Project	IEEE 802.16 Broadband Wireless Access Working Group < http://ieee802.org/16 >	
Title	Figures for the Comment Resolution	
Date Submitted	2002-10-15	
Source(s)	Itzik Kitroser Runcom Technologies Ltd. Homa 2 Rishon Lezion 75655 Israel	Voice: +972-3-9528440 /107 Fax: +972-3-9528805 itzikk@runcom.co.il
Re:	IEEE LMSC Sponsor Ballot recirculation of P802.16a/D5	
Abstract	Proposed material referenced by submitted comments.	
Purpose	Adoption	
Notice	This document has been prepared to assist IEEE 802.16. It is offered as a basis for discussion and is not binding on the contributing individual(s) or organization(s). The material in this document is subject to change in form and content after further study. The contributor(s) reserve(s) the right to add, amend or withdraw material contained herein.	
Release	The contributor grants a free, irrevocable license to the IEEE to incorporate material contained in this contribution, and any modifications thereof, in the creation of an IEEE Standards publication; to copyright in the IEEE's name any IEEE Standards publication even though it may include portions of this contribution; and at the IEEE's sole discretion to permit others to reproduce

Figure 55a-Periodic ranging - BS (CDMA Ranging case)

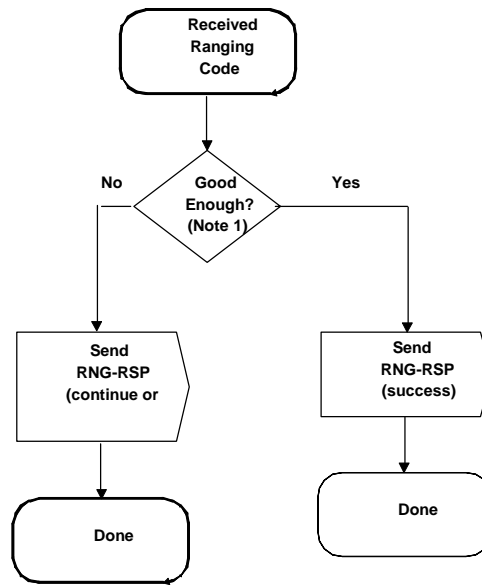
Use the following figures for the CDMA Ranging case (page 89).

Figure 128ax—Time Plan - One TDD time frame

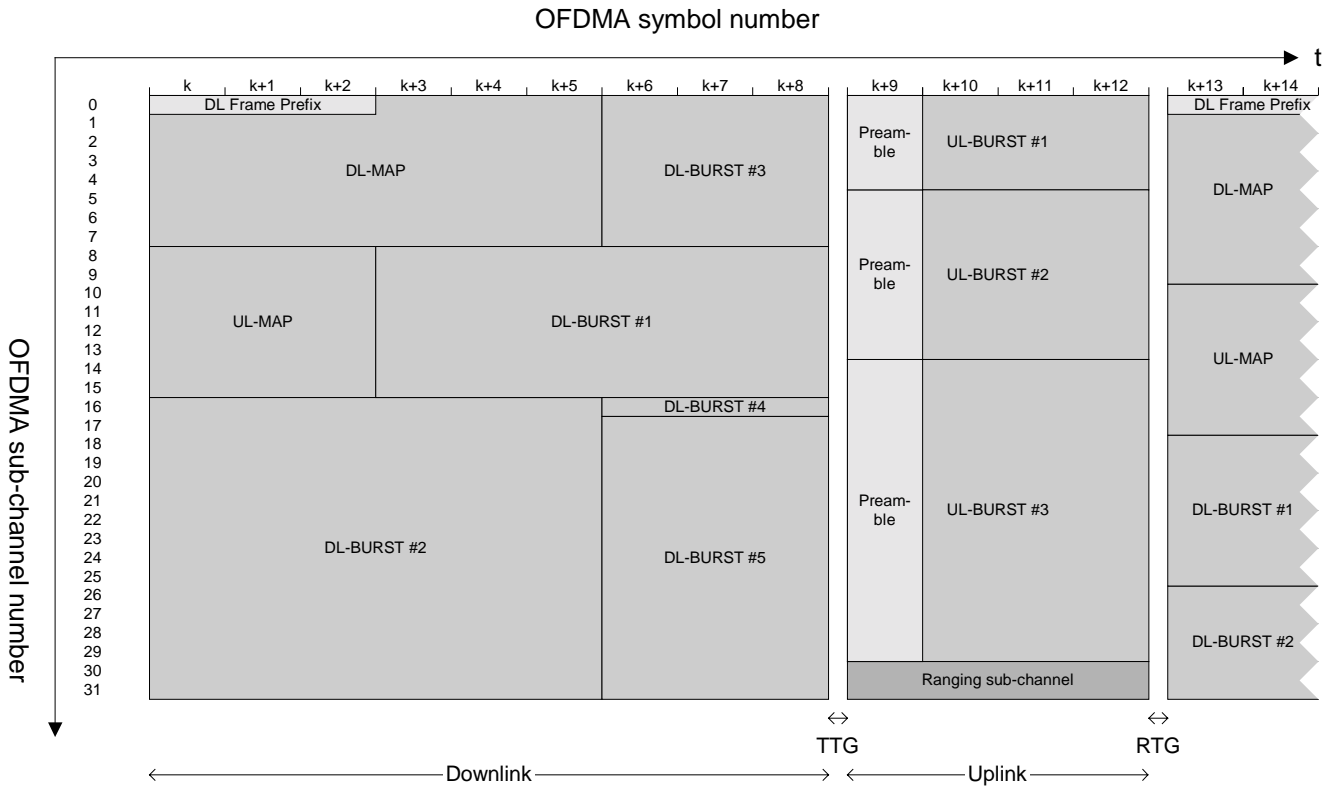
Add the following figure instead the one deleted (page 189, line 37, figure 128ax):
